Access Compliance Report

Public Rights-of-Way

(Curb Ramps)

Intersection ID: 49647	Main Street: STRAWBERRY_LN	Cross Street: GREENBRIAR_HILLS_PLANTATION_RD	Location: SW
ADA ID: 29265618BDFA	Ramp Type: PerpDiag	Initial Pass/Fail: Fail	Overall Compliance: No
Severity Score: 13.75			
Codes/Mitigation Info/Possible Solution		Field Measurements/Component Compliance

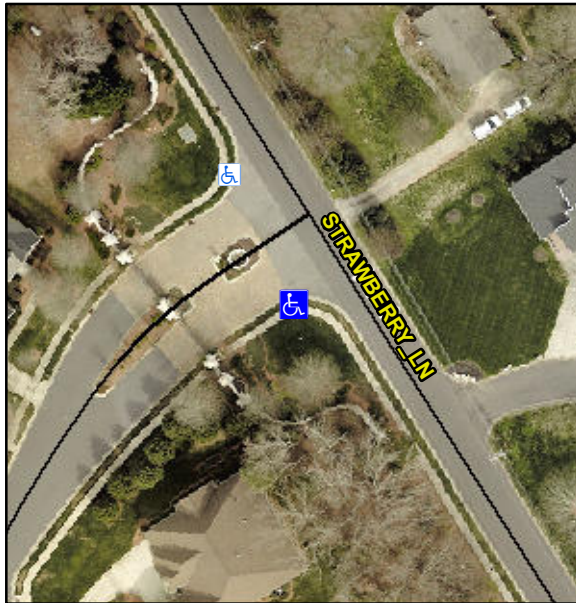
Not Found, R304.2.2, R304.5.3

Compliance	Description	Data	Compliance	Description	Data
N/A	Ramp Length (in)	47.0	No	Ramp Slope (%)	9.1
Yes	Ramp Width (in)	48.0	No	Ramp XSlope (%)	3.2
N/A	Flare Type LT	N/A	N/A	Flare Type RT	N/A
N/A	Flare Slope LT (%)	N/A	N/A	Flare Slope RT (%)	N/A
N/A	Flare Traversable LT?	N/A	N/A	Flare Traversable RT?	N/A
N/A	Landing Length (in)	N/A	N/A	DWS Provided?	N/A
N/A	Landing Width (in)	N/A	N/A	DWS Contrast?	N/A
N/A	Landing Slope (%)	N/A	N/A	DWS Length (in)	N/A
N/A	Landing X Slope (%)	N/A	N/A	DWS Full Width?	N/A
N/A	Landing Curb? (Y/N)	N/A	N/A	DWS Offset (in)	N/A
N/A	Shared Landing?	N/A			
N/A	Gutter Ponding?	N/A	N/A	Gutter Slope (%)	N/A
N/A	Gutter Lip Ht (in)	N/A	N/A	Gutter X Slope (%)	N/A
N/A	Painted X Walk1?	No	N/A	Painted X Walk2?	No
	X Walk 1 Direction	To NE		X Walk 2 Direction	To N
N/A	X Walk 1 Width (in)	N/A	N/A	X Walk 2 Width (in)	N/A
	X Walk 1 Slope (%)	3.3		X Walk 2 Slope (%)	6.1
	X Walk 1 X Slope (%)	5.2		X Walk 2 X Slope (%)	2.2

Remove & Replace Curb Ramp With Two New Directional Ramps or Equivalent.
